Errata/suggestions for TI/DSPC setup guide

AM62D Audio SDK 11.02

AudioSdk_Users_Guide.html

Audio Signal-Chain Processing

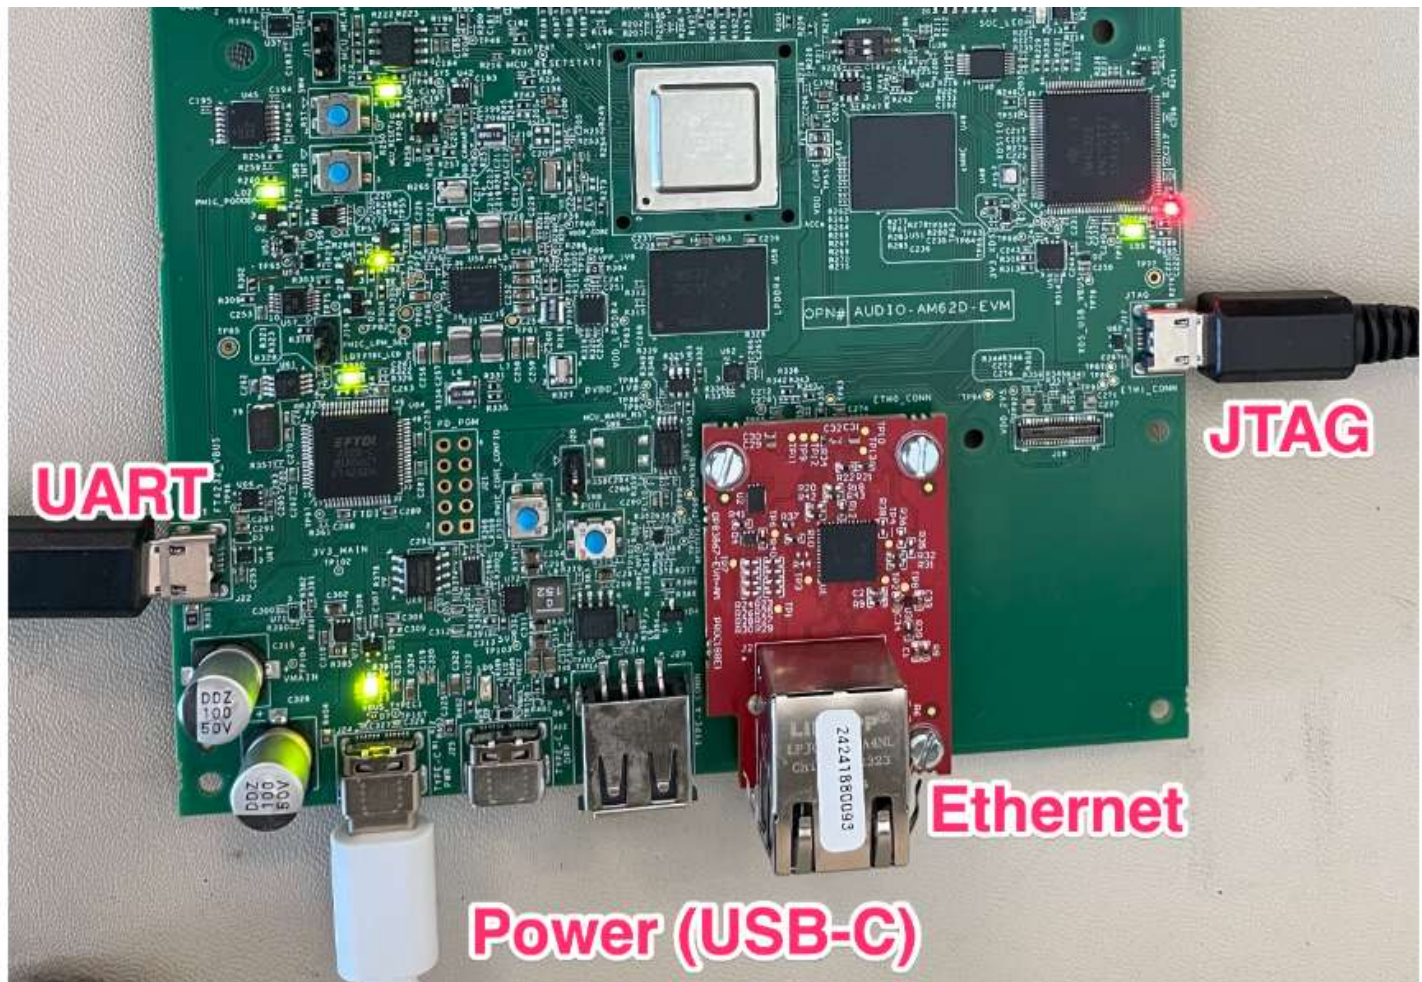
- Audio signal-chain processing on C75x/A53 core
- Multi-rate, multi-thread audio processing
- Low-latency audio path for small audio sample rates
- Normal audio processing on higher sample rates

Should say:

- Low-latency audio path for small block size
- Normal audio processing for higher block sizes

Config3: Multi-Instance C7x, A53/core0 & MCU/R5F

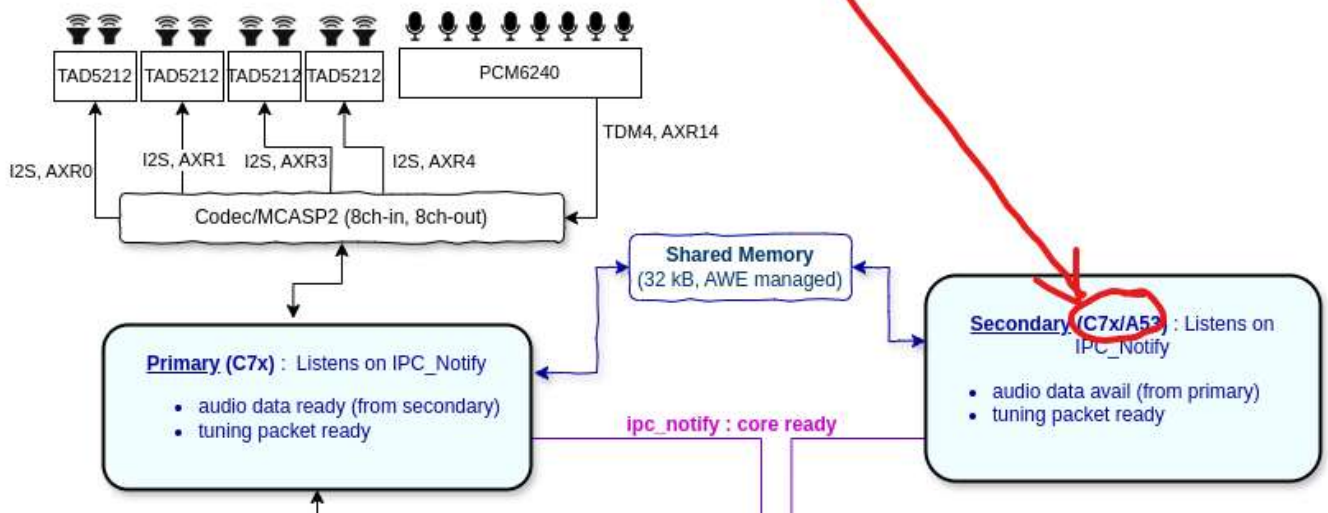
I believe that "C7x/A53" in the right hand box really wants to say "A53/Core0".
